THE MARYLAND-NATIONAL CAPITAL PARK & PLANNING COMMISSION

MEMORANDUM

REVIEW TYPE: Site Plan Review
APPLYING FOR: Mixed use development:
92 residential housing units including 12 MPDUs
123,383 sf general retail, including 87,237 sf existing retail and 44,146 sf new retail space

PROJECT NAME: **Bethesda View**
CASE #: Site Plan #8-04024
REVIEW BASIS: Division 59-D-3: Site Plan Review required for Optional Method in the CBD-1 Zone

Sectional drawing showing the apartment building on the right, the public alley at center, and the proposed building's vehicular access at the right. Coniferous trees planted at eight feet are shown screening the existing windows.

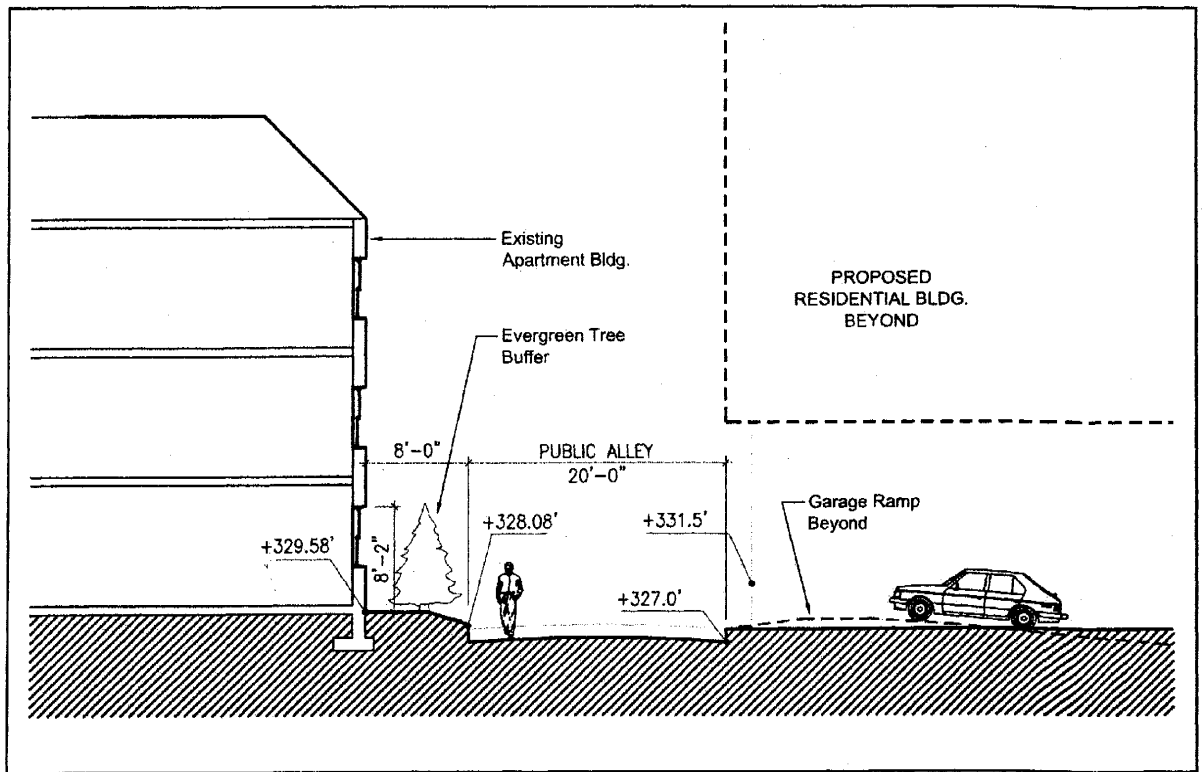
The proposed new garage entrance via the public alleyway will negatively impact the residents of the rental units because of its close proximity. The owner has requested via telephone conversation that the applicant provide landscaping and replacement windows for the south façade of the building to minimize the impact of air pollution, traffic congestion and noise attributable to vehicles and operation of the garage gate.

The use of the alley for residential passage promises a less intense level of activity and a type and frequency of use that is similar to that generated by the apartment residents. Site plan review included relevant study of the area immediately impacted by the garage access, including analysis of the adjacent building's façade, grade levels of the garage and the alley, and directional elevation heights of headlights. The applicant proposes appropriate mitigation for the attendant impacts of the new development, as follows:

1. Landscaping is of adequate density and height screen headlight glare;
2. Planting depth and area dimension are sufficient to ensure the longevity of the planting;
3. Vehicle headlights will not shine directly into the apartment windows because the surface grade of the alley and garage exit ramp is sufficiently lower than the sills of the apartment windows.
4. Change to the garage traffic pattern will reduce some of the new resident vehicular traffic in the alleyway;
5. The elimination of the commercial use of the alley will result in an activity level that is more compatible with the adjoining residential use.

The applicant proposed to eliminate the existing use of the alley for commercial loading and trash pick-up. Residential vehicular use expected to assume a greater proportion of the activity within the alley. The new garage design features a security gate that is recessed significantly within the building itself. The applicant also proposed landscaping with coniferous trees for the area directly adjacent to the apartment building.

Detail showing curb realignment recommended for Strathmore Street. The blue line shows the existing curb, the red line shows the new curb line. The new alignment will promote traffic calming.

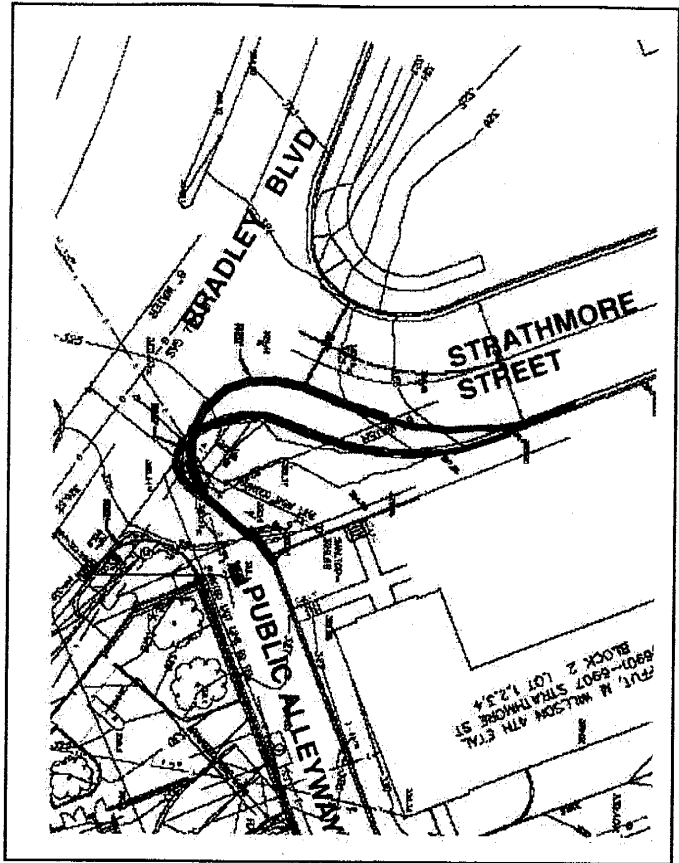
The agency requested a slightly larger turning radius at the entrance to the public alley to increase the spacing between the two curb cuts on Bradley Boulevard. The realignment will ease the movement of traffic into and out of the alleyway.

The two agencies concur with the recommendation of SHA and find that the realignment will enhance both pedestrian and vehicular safety. Both agencies recommended that the community be notified of the proposed design recommendations.

Staff supports the recommendations of SHA And the opinion of DPS and DPWT that The realignment will promote greater pedestrian and vehicular safety. Staff finds that the realignment may discourage non-local traffic from using Strathmore Street, and achieve some measure of traffic calming. A plan showing the proposed realignment was mailed to all appropriate parties as an attachment to the hearing notice.
